UNCW Housing Village Phase III – Building Package

Addendum #1

Description | **Prebid Question & Answer Log**
Project | **HOUSING VILLAGE PHASE III - Building Package**
Owner | **UNIVERSITY OF NORTH CAROLINA AT WILMINGTON**
Update Date | **Wednesday, March 4, 2026**

1 ELECTRICAL SITE UTILITY NEW WORK PLAN
 1" = 20' 0"

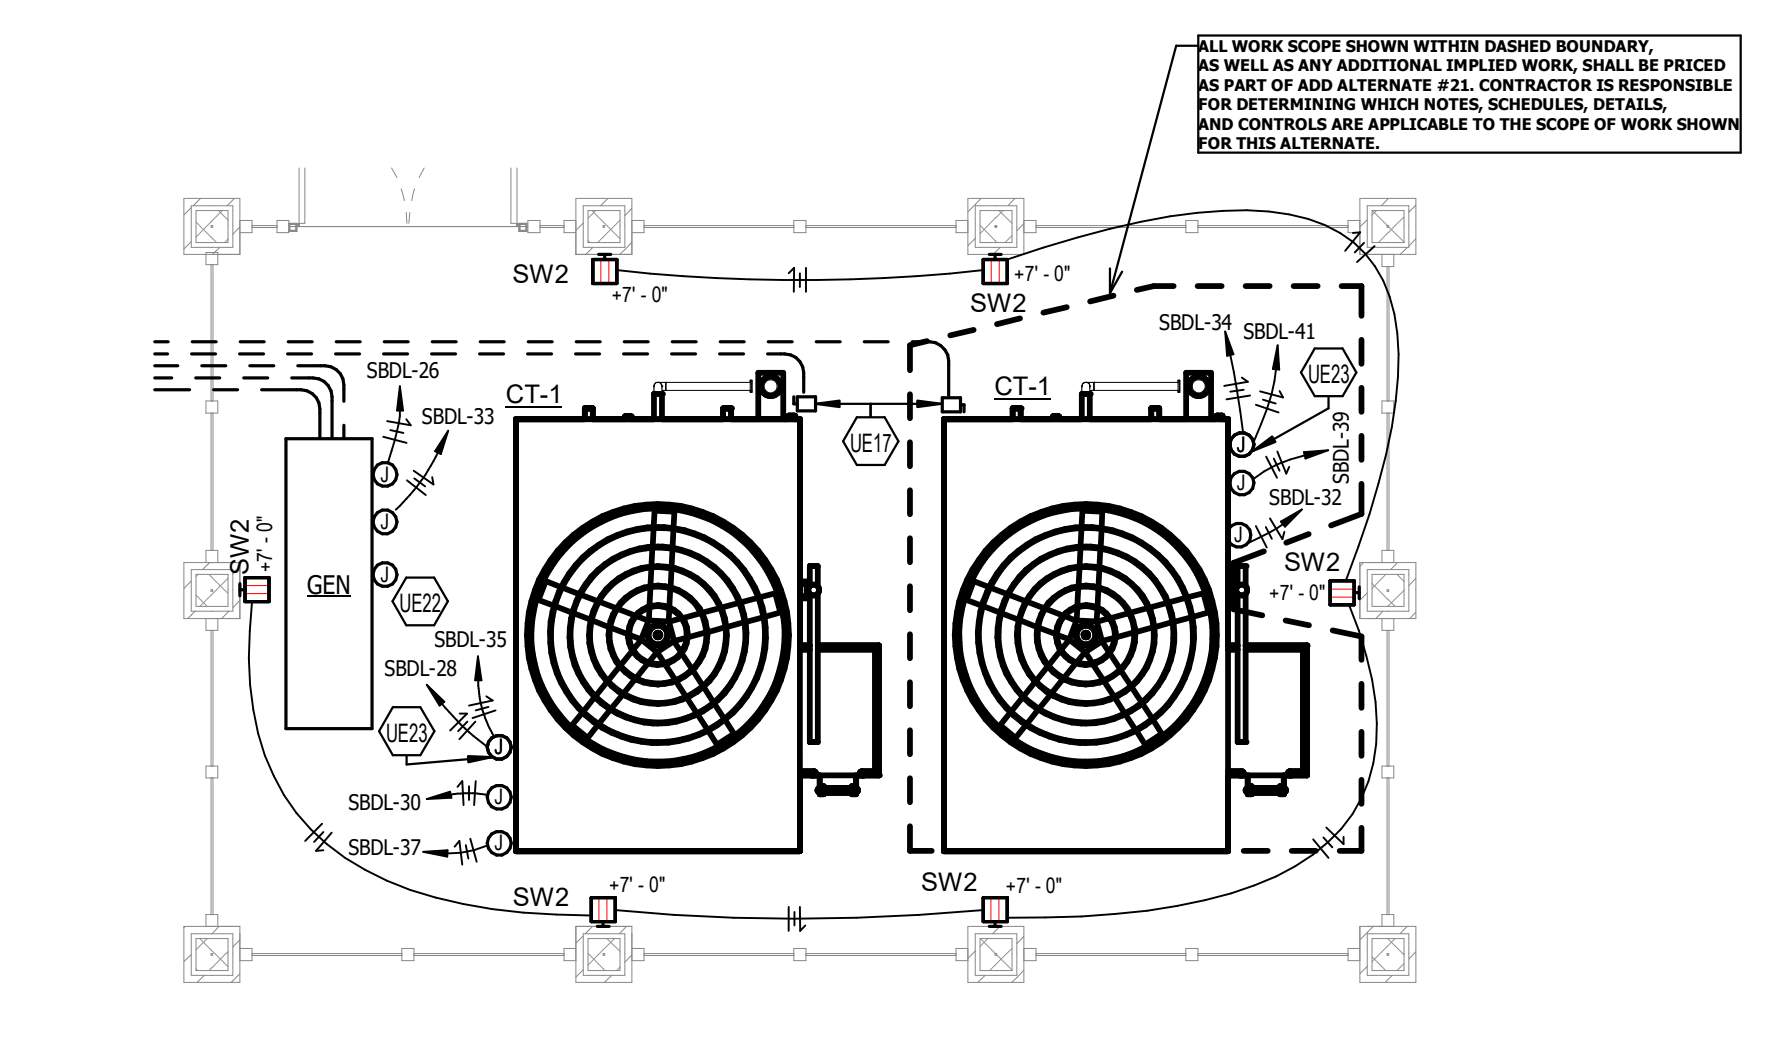
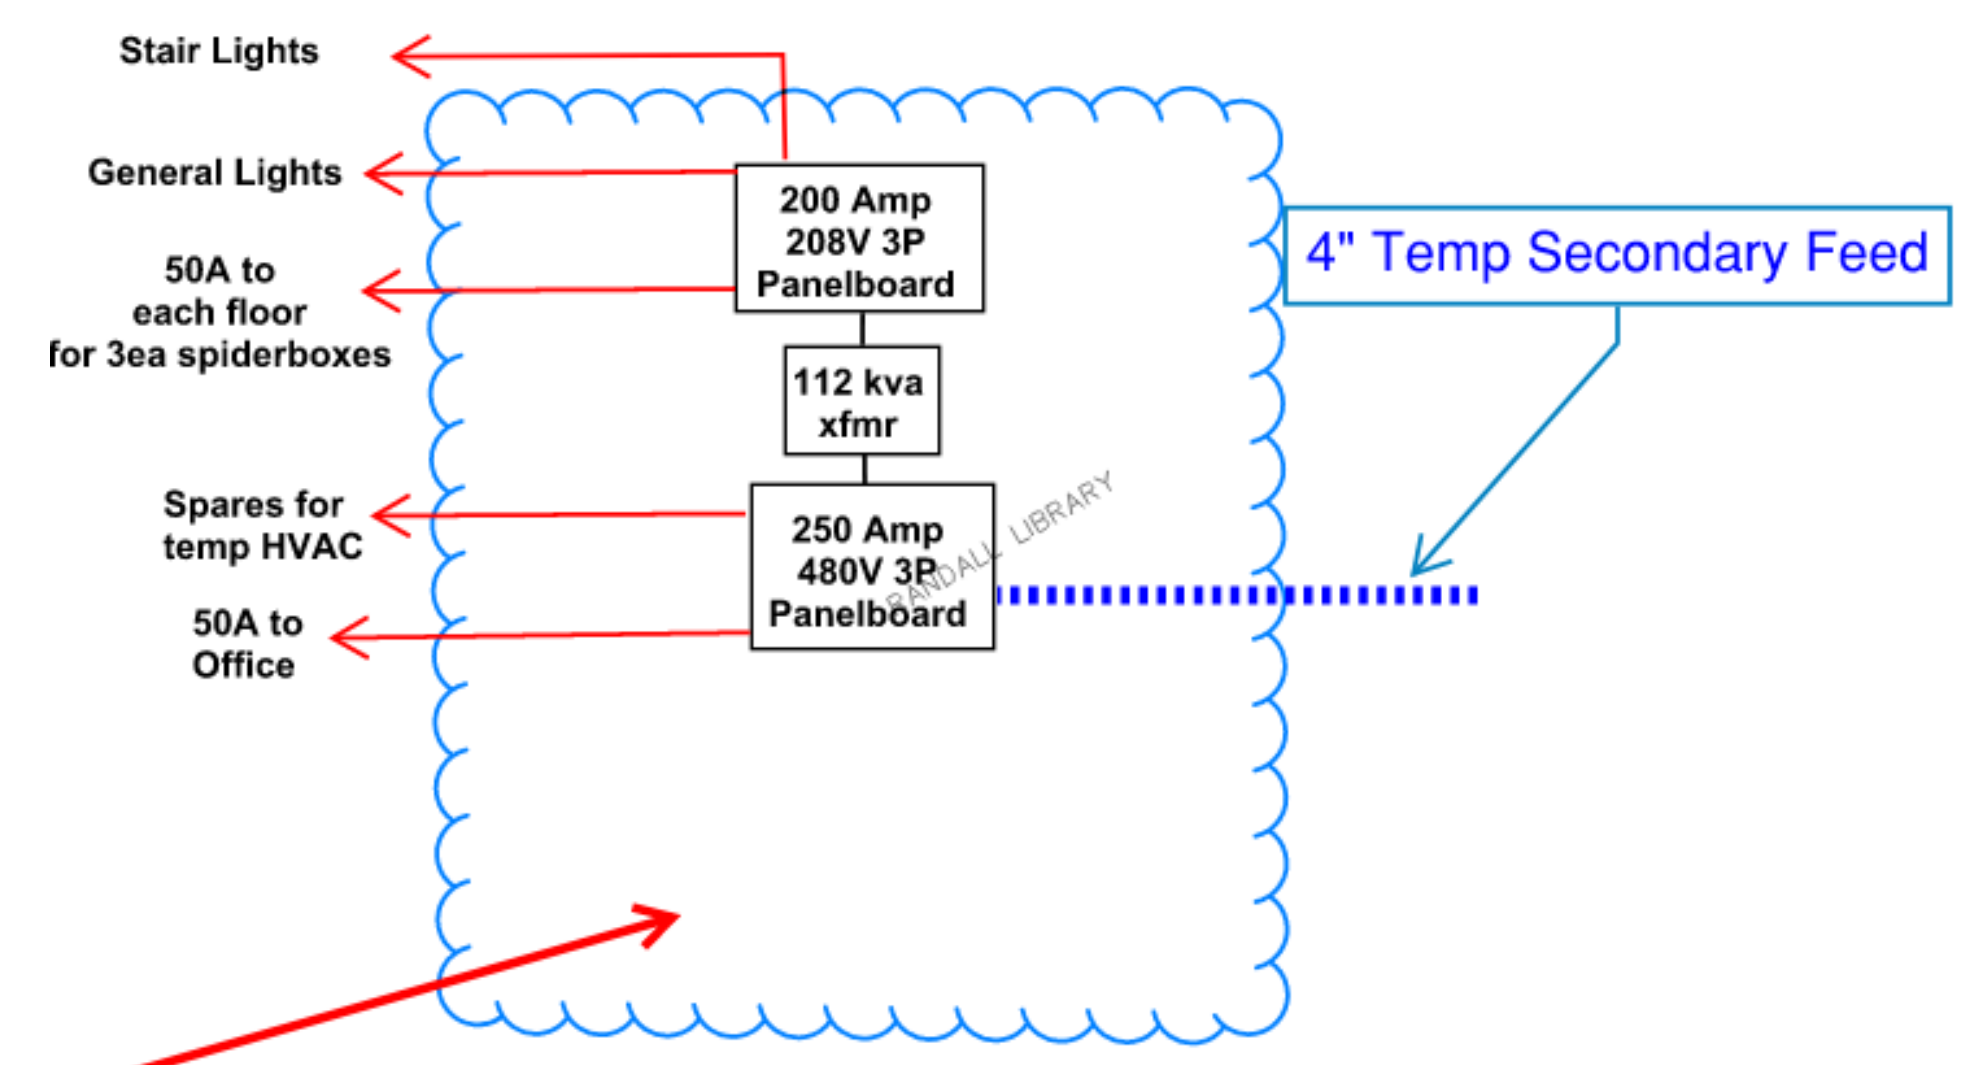
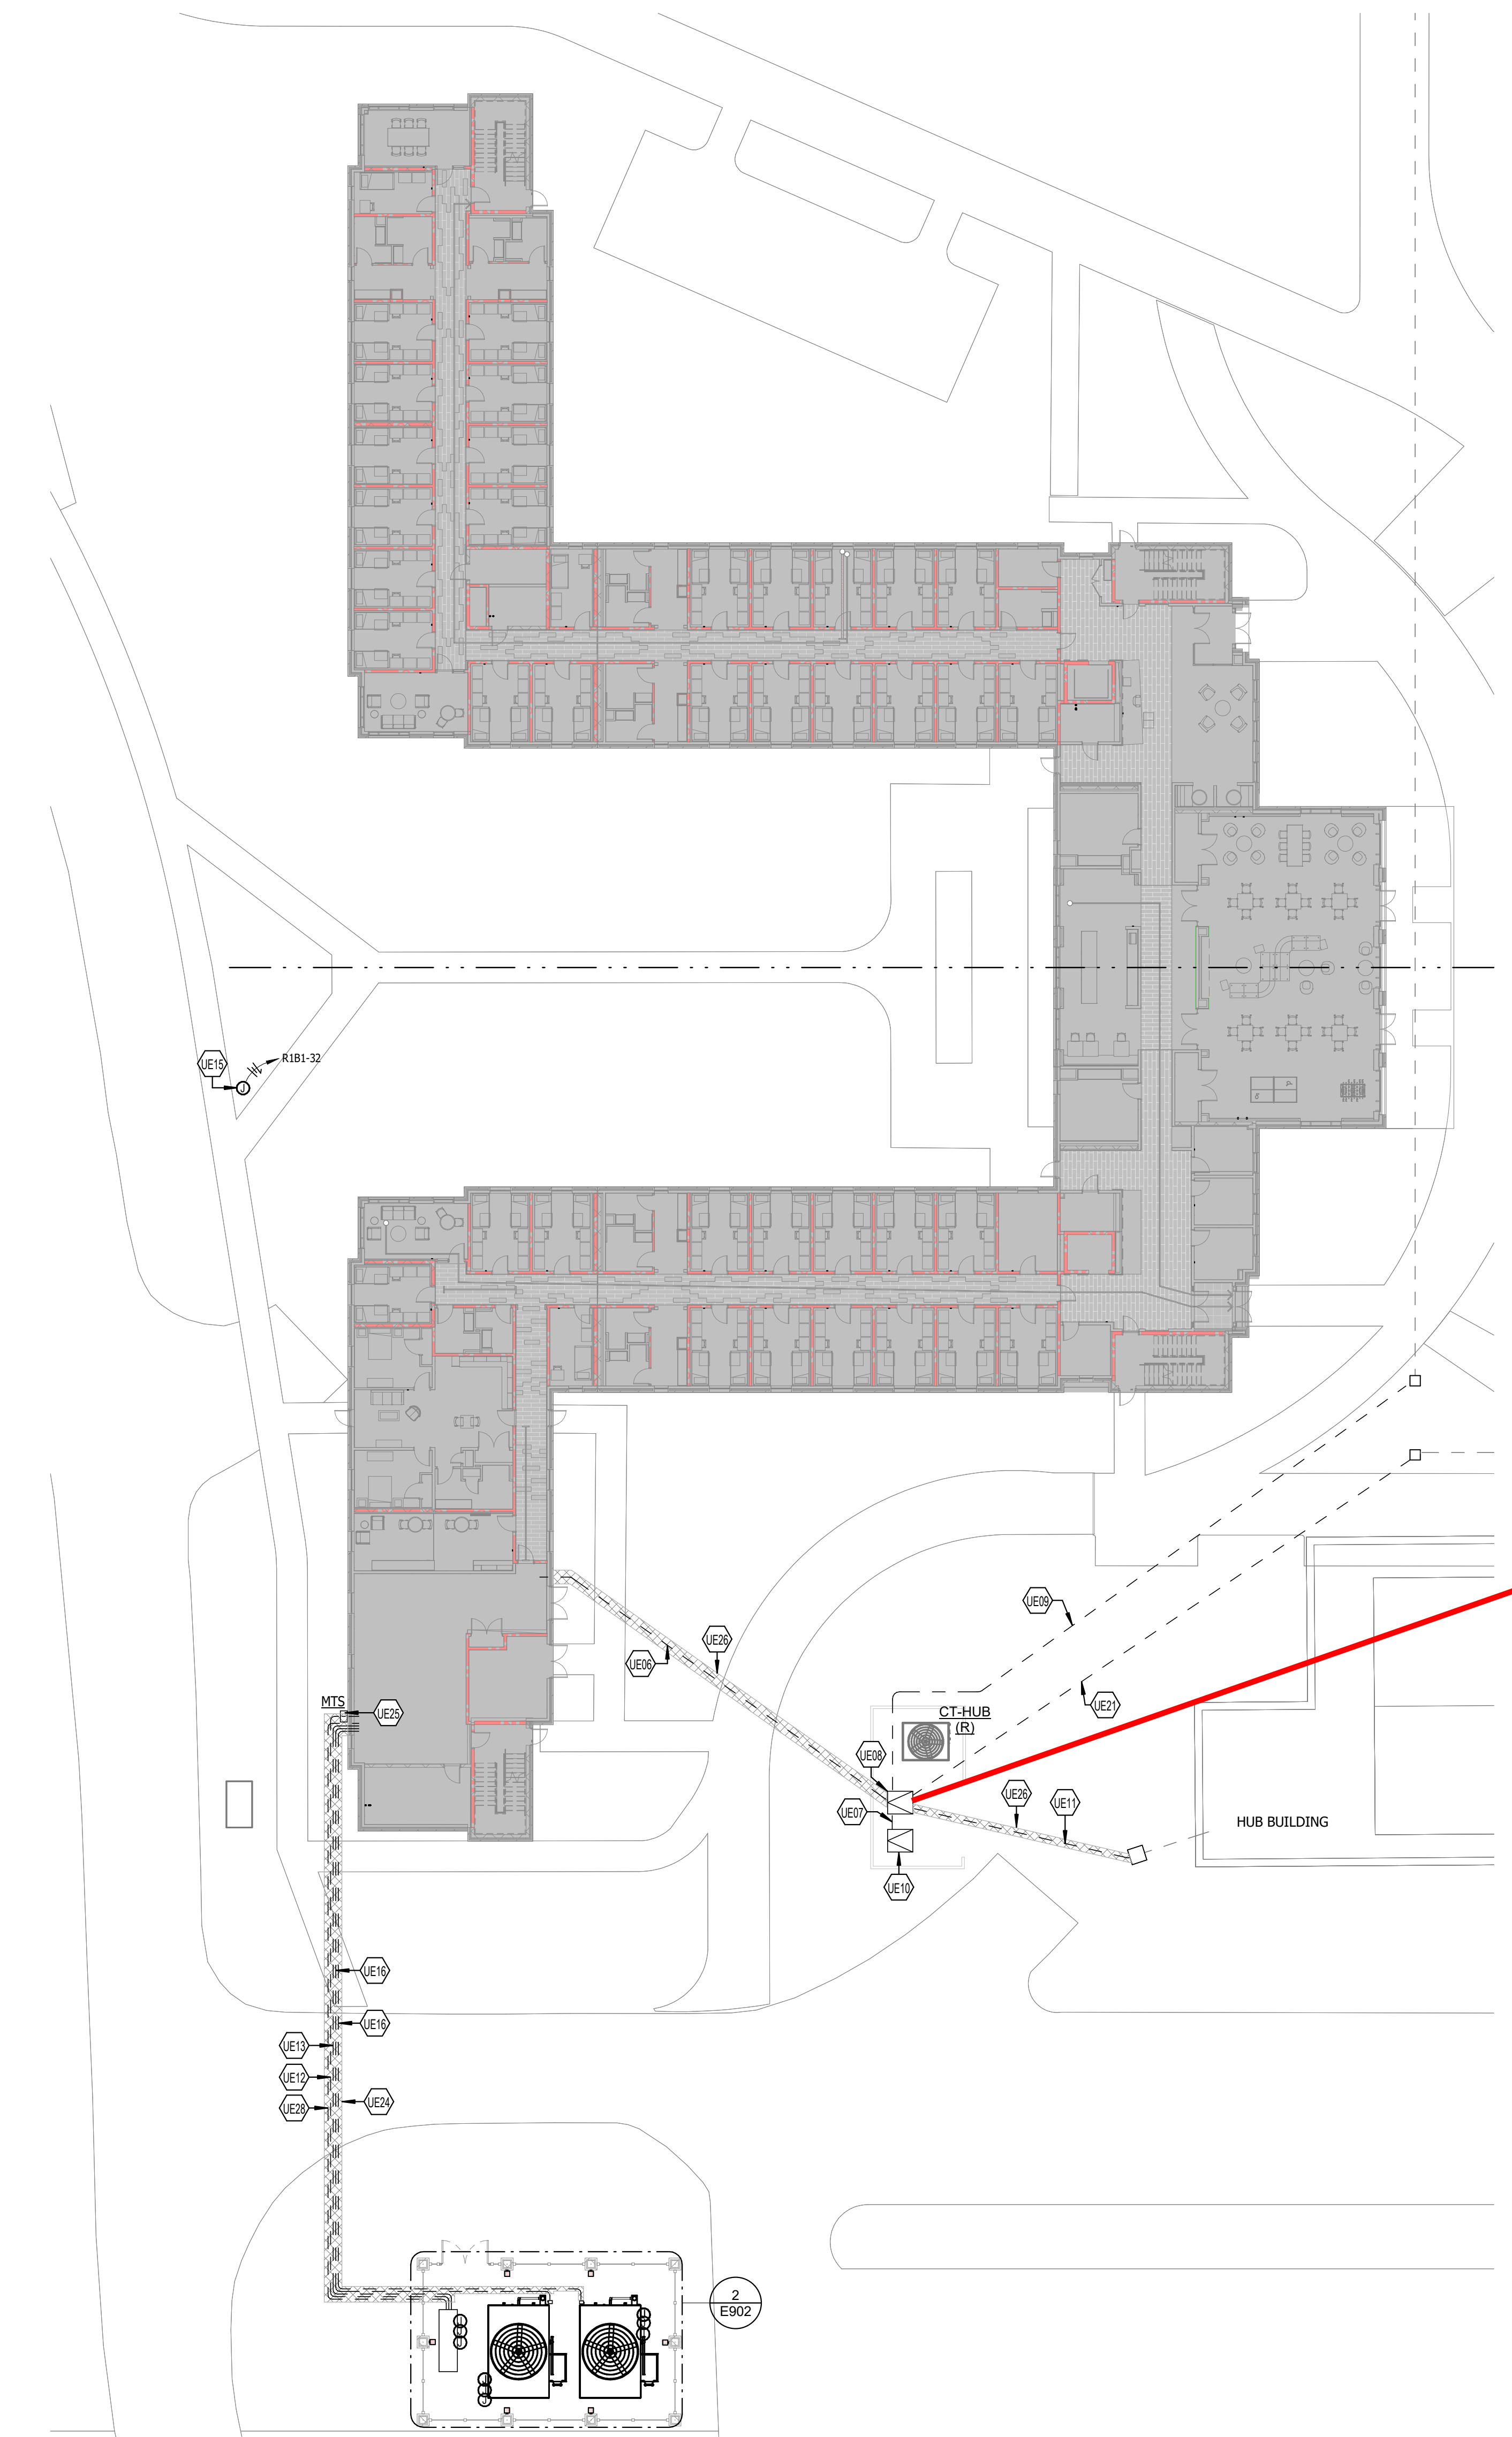
- UE15 PROVIDE 120V CONNECTION FOR BLUELIGHT PEDESTAL.
 - UE16 PROVIDE NEW COOLING TOWER BRANCH CIRCUIT FROM SERVICE SWITCHBOARD "SSW" TO MECH YARD WITHIN DUCTBANK. REFER TO ONE-LINE DIAGRAM FOR CONDUIT/CONDUCTOR SIZING.

- UE17 PROVIDE 600V, 100A/3P, NEMA 3R, FUSED DISCONNECT SWITCH FOR NEW COOLING TOWER. PROVIDE FUSES PER MANUFACTURER'S RECOMMENDATIONS/GUIDELINES. COORDINATE FINAL LOCATION WITH MECHANICAL CONTRACTOR.

- UE24 PROVIDE CONCRETE ENCASED DUCT BANK FOR LIFE SAFETY & OPTIONAL STANDBY BRANCH FEEDERS FROM GENERATOR AND COOLING TOWER BRANCH CIRCUITS. FIELD COORDINATE EXACT ROUTING. INSTALL SUCH THAT TOP OF CONCRETE IS 24" BELOW GRADE MINIMUM. REFER TO ONE-LINE DIAGRAM FOR CONDUIT/CONDUCTOR SIZING. REFER TO DUCT BANK DETAIL FOR MORE INFORMATION.
